RE: Water Right, File Nos. 28286

## APPROVAL OF APPLICATION FOR CHANGE IN POINT OF DIVERSION AND ORDER IN THE MATTER OF THE AUTHORIZED RATE OF DIVERSION AND QUANTITY OF WATER AND ORDER TO BETTER DESCRIBE THE AUTHORIZED PLACE OF USE WATER RIGHT, FILE NO. 28,286

### Change in Point of diversion WR 28286 Section 31 T22 R34W Finney Co.

**Figure 1:** Location of current, proposed and nearby domestic well. Labeled transmissivity (T) and saturated thickness (ST) are GMD No. 3 model section-average projected for year 2068.

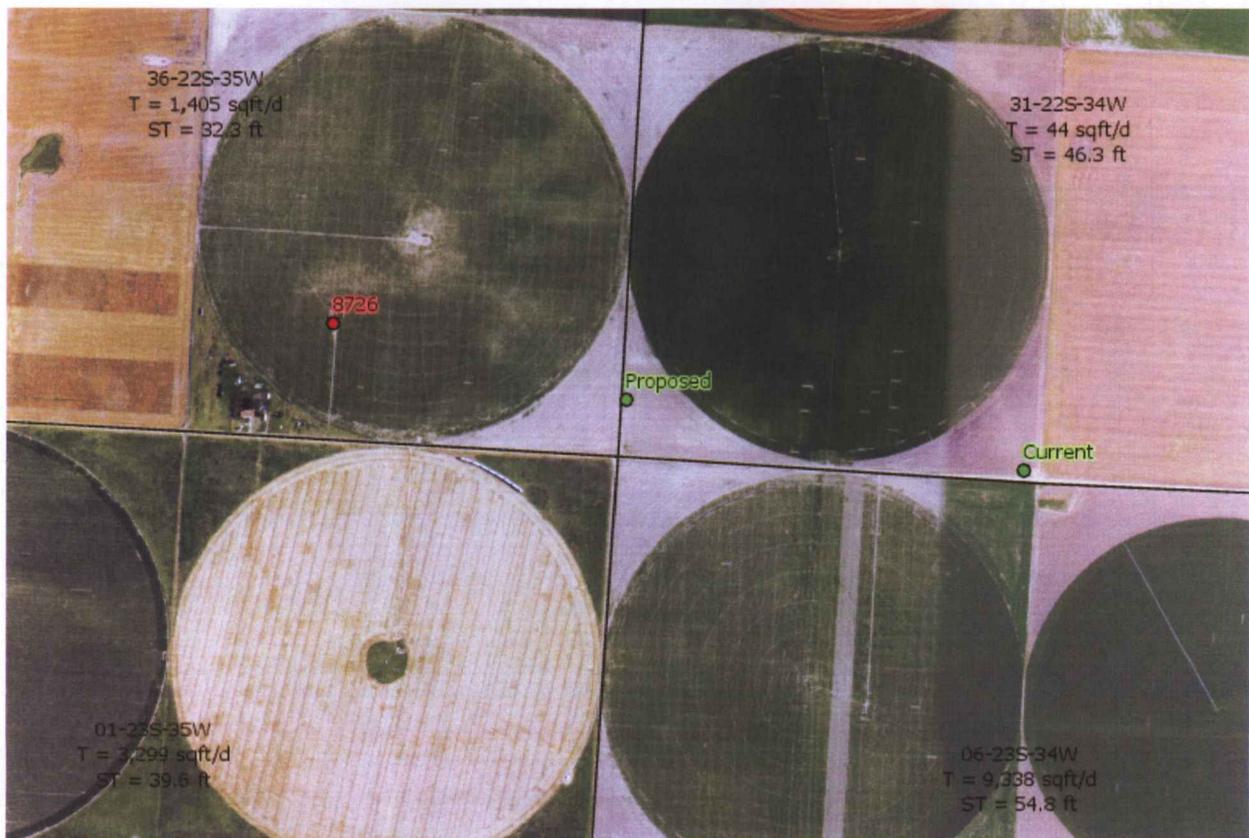
A 50-year Theis analysis was used to evaluate the effect of a proposed change in point of diversion for File No. 28,286 on the well authorized by File No. 8,726 (Figure 1). A transmissivity of 724 square feet per day was used, which is the average of the GMD No. 3 model, 2068 projected transmissivities for sections 36 and 31. Storativity was assumed to be 0.0004, which is a conservative value based on an assumed specific storage of  $10^{-4}$ . A proposed pumping scenario of 156 acre-feet per year at 300 gallons per minute was compared to historical use (149 AF at 400 gpm, 2009-2018). The maximum difference in drawdown between the proposed and baseline scenarios after 50 years of pumping cycles is 6.46 feet, or 20.00% of the 50-year projected saturated thickness (Table 1).

**Figure 1:** Location of current, proposed and nearby domestic well. Labeled transmissivity (T) and saturated thickness (ST) are GMD No. 3 model section-average projected for year 2068.

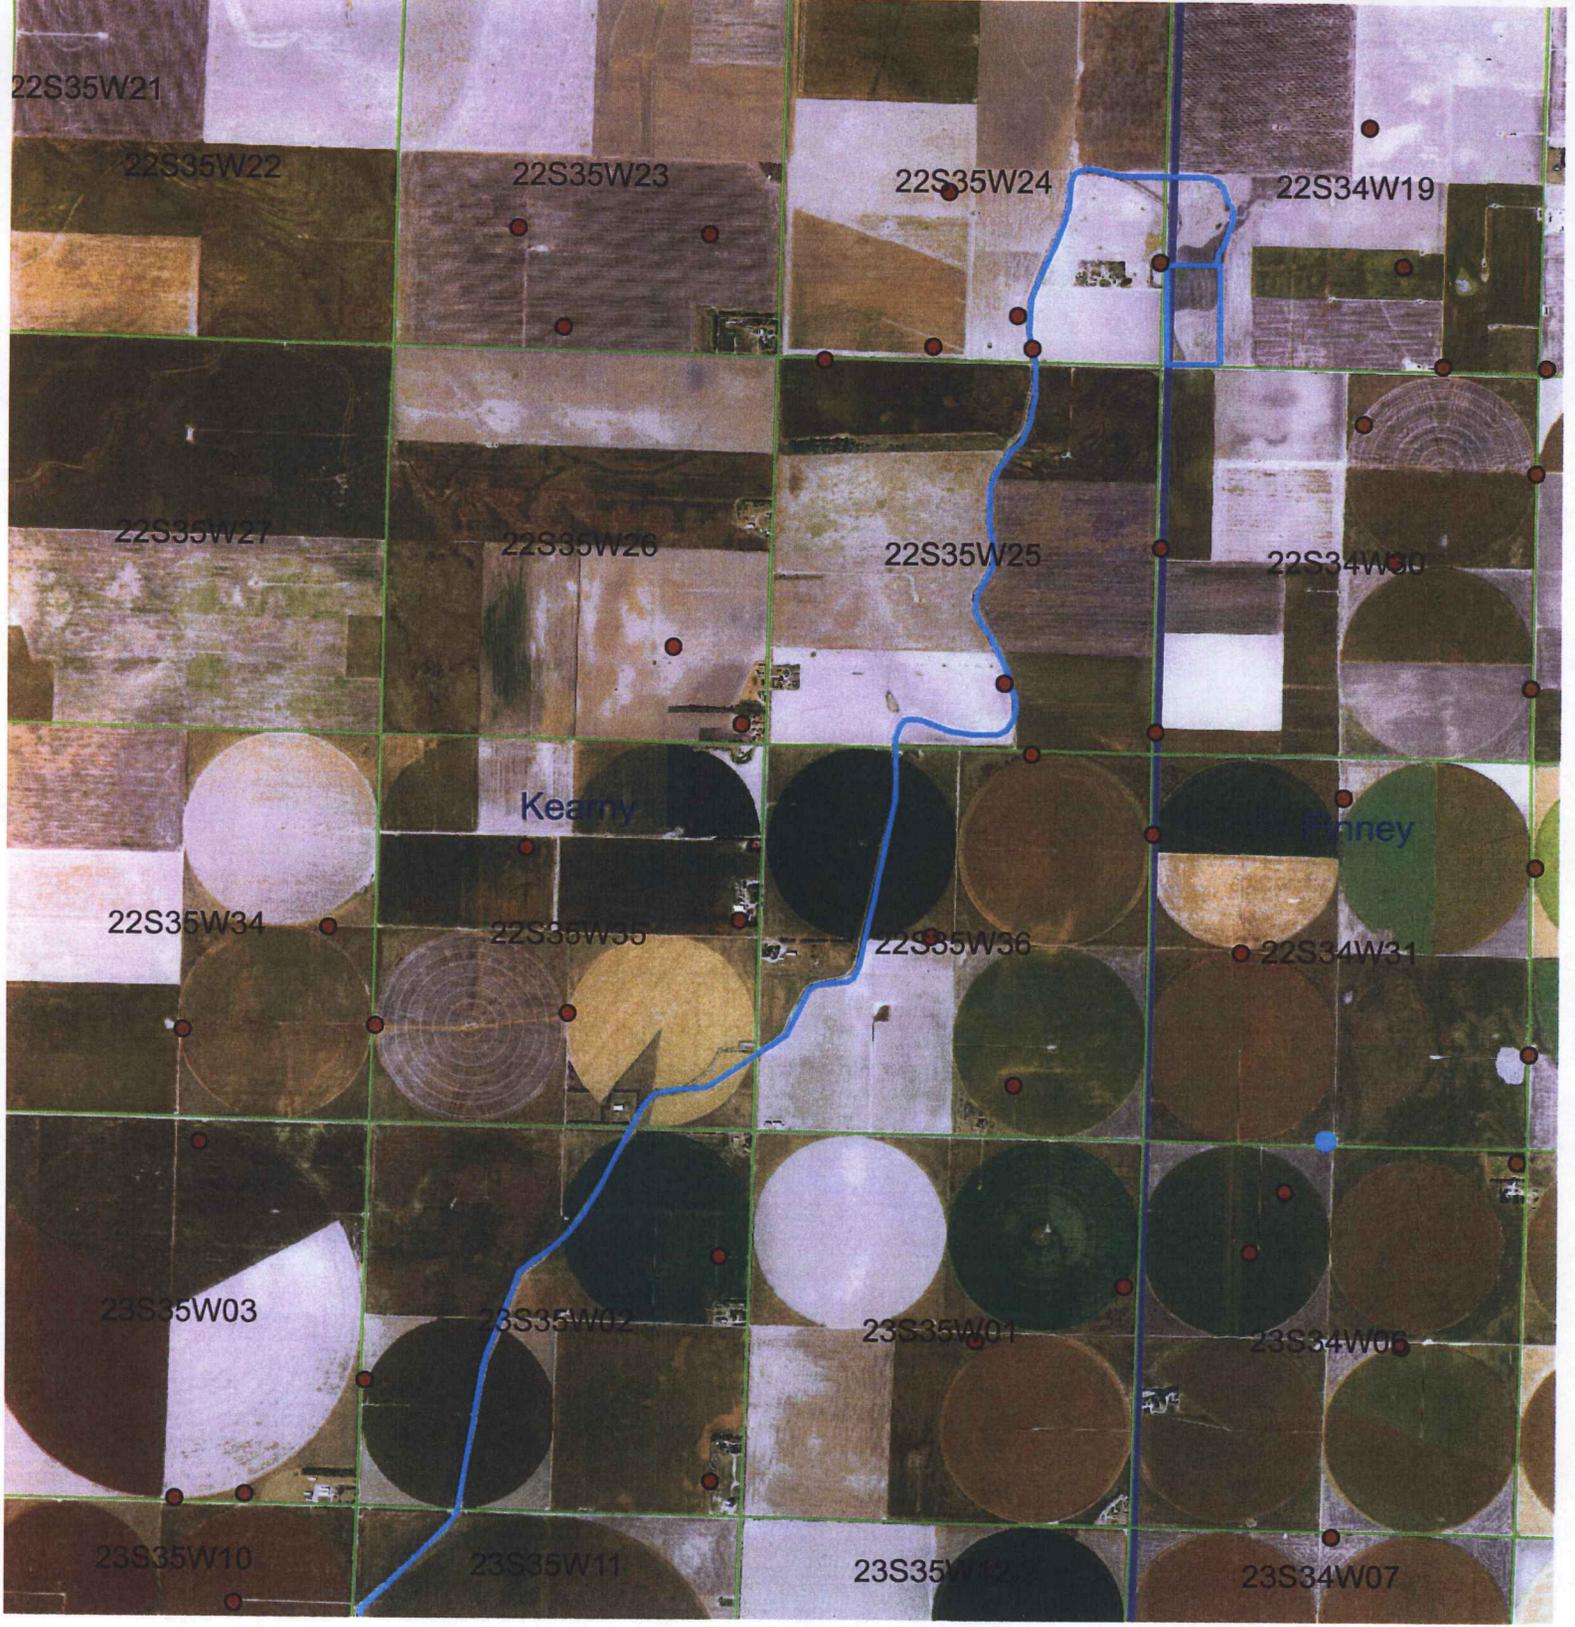
A 50-year Theis analysis was used to evaluate the effect of a proposed change in point of diversion for File No. 28,286 on a domestic well 2,312 feet west of the proposed location (Figure 1). A transmissivity of 724 square feet per day was used, which is the average of the GMD No. 3 model, 2068 projected transmissivities for sections 36 and 31. Storativity was assumed to be 0.0004, which is a conservative value based on an assumed specific storage of  $10^{-4}$ . A proposed pumping scenario of 156 acre-feet per year at 300 gallons per minute was compared to historical use (149 AF at 400 gpm, 2009-2018). The maximum difference in drawdown between the proposed and baseline scenarios after 50 years of pumping cycles is 4.93 feet, or 15.26% of the 50-year projected saturated thickness (Table 1).

**Figure 1:** Location of current, proposed and nearby File No. 8,726. Labeled transmissivity (T) and saturated thickness (ST) are GMD No. 3 model section-average projected for year 2068.

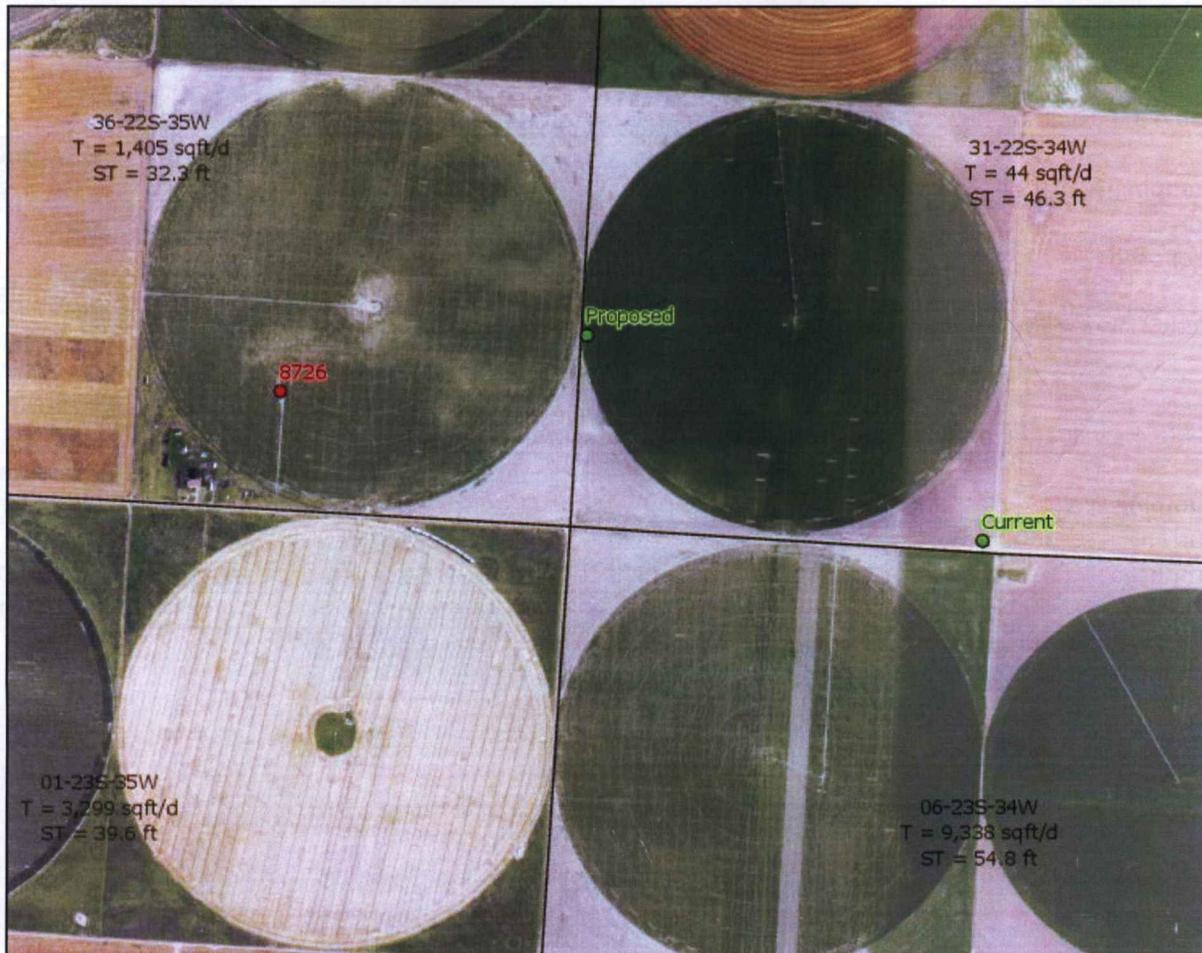
A 50-year Theis analysis was used to evaluate the effect of a proposed change in point of diversion for File No. 28,286 File No. 8,726 (Figure 1). A transmissivity of 724 square feet per day was used, which is the average of the GMD No. 3 model, 2068 projected transmissivities for sections 36 and 31. Storativity was assumed to be 0.0004, which is a conservative value based on an assumed specific storage of  $10^{-4}$ . Two proposed pumping scenarios were evaluated: 320 acre-feet (AF) per year at 790 gallons per minute (gpm) and at 400 gallons per minute. These scenarios were compared baseline scenarios of presently authorized (320 AF at 790 gpm) and historical use (149 AF at 400 gpm, 2009-2018). The maximum difference in drawdown between the proposed and baseline scenarios after 50 years of pumping cycles is presented in Tables 1 through 4.

**Figure 1:** Location of current, proposed and nearby domestic well. Labeled transmissivity (T) and saturated thickness (ST) are GMD No. 3 model section-average projected for year 2068.

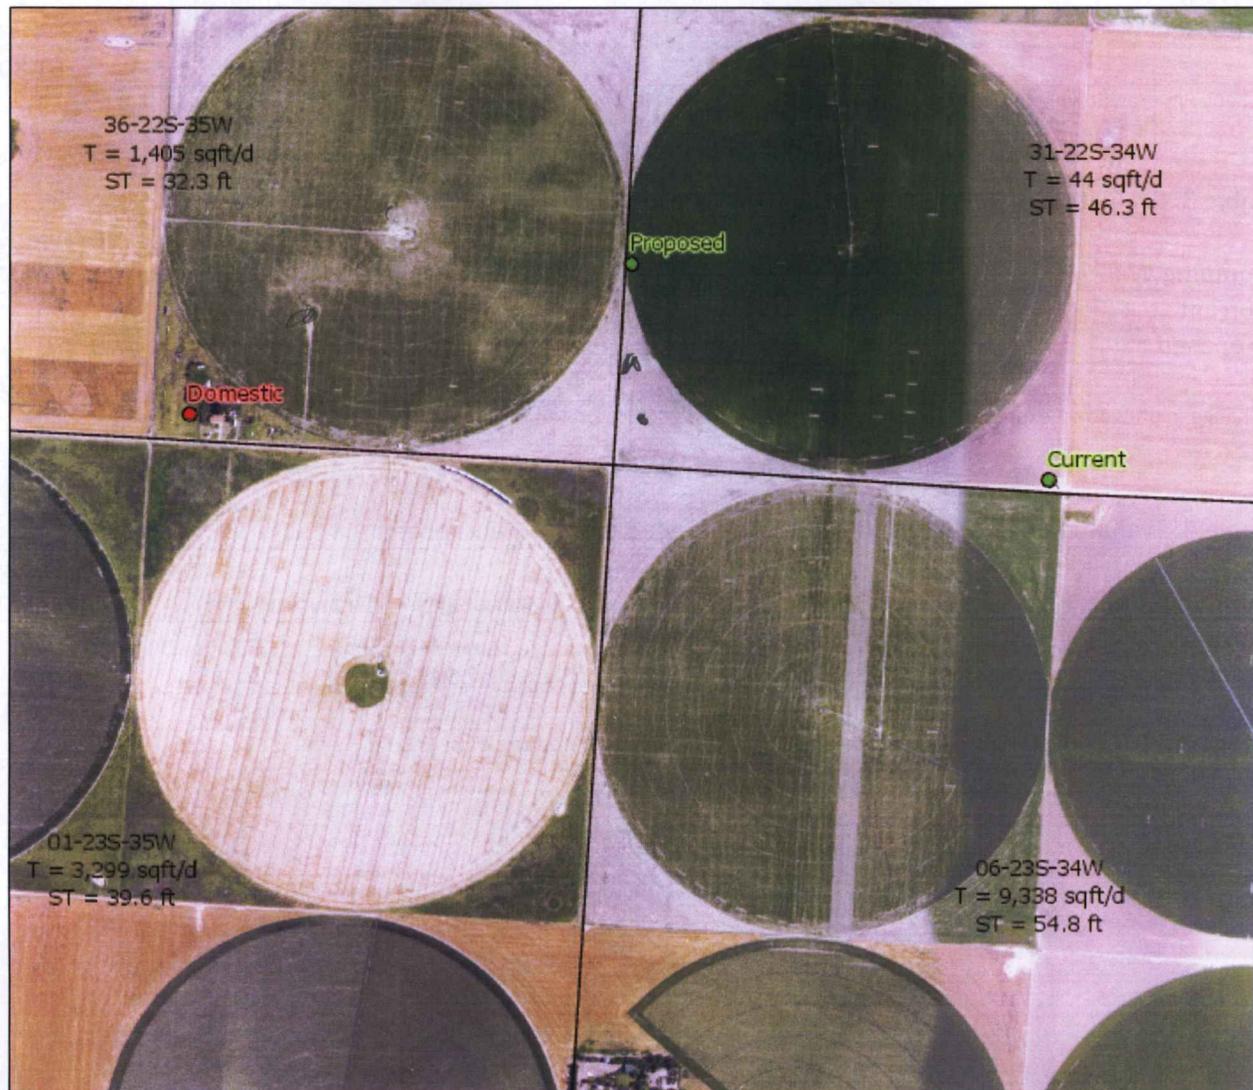
A 50-year This analysis was used to evaluate the effect of a proposed change in point of diversion for File No. 28,286 on a domestic well located 1,225 feet west of the proposed location (Figure 1). A transmissivity of 724 square feet per day was used, which is the average of the GMD No. 3 model, 2068 projected transmissivities for sections 36 and 31. Storativity was assumed to be 0.0004, which is a conservative value based on an assumed specific storage of  $10^{-4}$ . Two proposed pumping scenarios were evaluated: 320 acre-feet (AF) per year at 790 gallons per minute (gpm) and at 400 gallons per minute. These scenarios were compared baseline scenarios of presently authorized (320 AF at 790 gpm) and historical use (149 AF at 400 gpm, 2009-2018). The maximum difference in drawdown between the proposed and baseline scenarios after 50 years of pumping cycles is presented in Tables 1 through 4.
